Quantum Corporation
500 McCarthy Boulevard
Milpitas, CA 95035 USA

To: T10 Technical committee
From: Mark Evans
Phone: 408-894-4019
Email: mark.evans@quantum.com
Date: 16 January 2001

Subject: Proposal for Ultra320 SCSI timing skew specification for SPI-4

Figure y – Example of transmitter skew

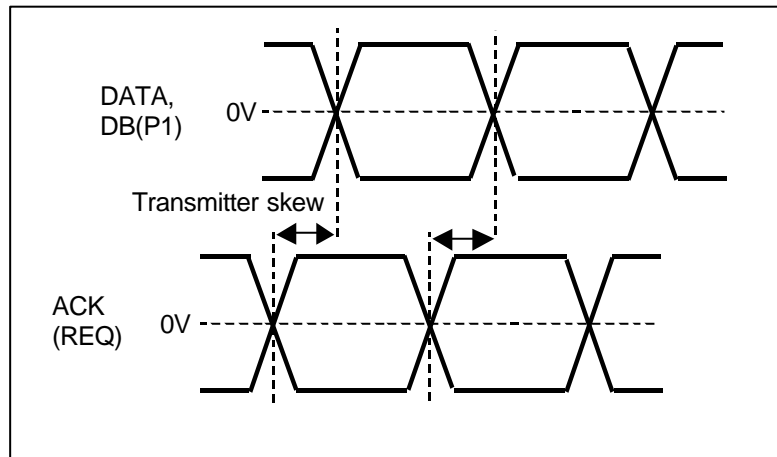
9.2.a Transmitter skew

The maximum difference in time allowed between the rising or falling edge of a “1010...” pattern on the DATA BUS or DB(P1) and its clocking signal on ACK(REQ) as measured at their zero-crossing points. The signals for the output waveforms shall be measured at the connector of the transmitting device under the test conditions as described in A.2.6.

Figure x – Example of transmitter time asymmetry

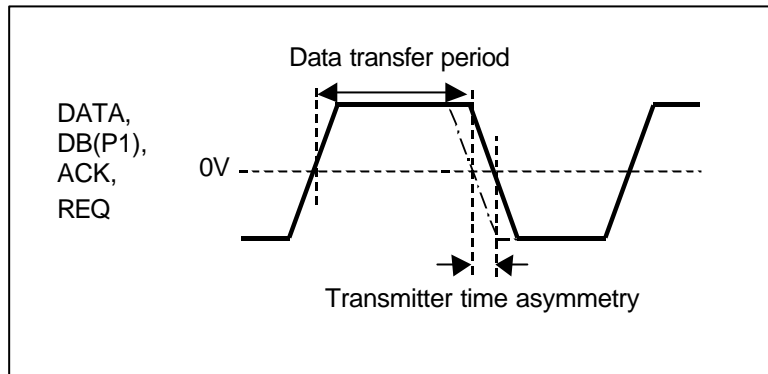
9.2.b Transmitter time asymmetry

The maximum time on DATA BUS, DB(P1), or ACK(REQ) from any transition edge to the subsequent transition edge during a “1010...” pattern, as measured at their zero-crossing points, minus the data transfer period. The signals for the output waveforms shall be measured at the connector of the transmitting device under the test conditions as described in A.2.6.

Figure z – Example of receiver de-skew parameters

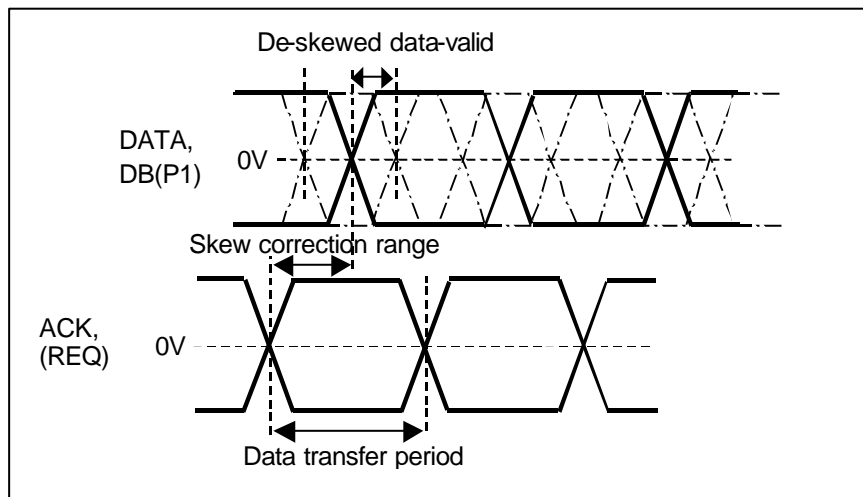
9.2.d De-skewed data-valid window

The minimum difference in time allowed between the rising or falling edge of a "1010..." pattern on the DATA BUS or DB(P1) and its clocking signal on ACK(REQ) as measured at their zero-crossing points after skew compensation is applied by the receiver without allowing any error in the received data. The de-skewed data-valid window shall be equal to $\pm [(\text{data transfer period}) - (\text{residual skew error}) - (\text{strobe offset tolerance}) - (\text{clock jitter}) - (\text{receiver amplitude skew}) - (\text{chip noise}) - (\text{system noise at receiver}) - (\text{receiver asymmetry})] \div 2$.
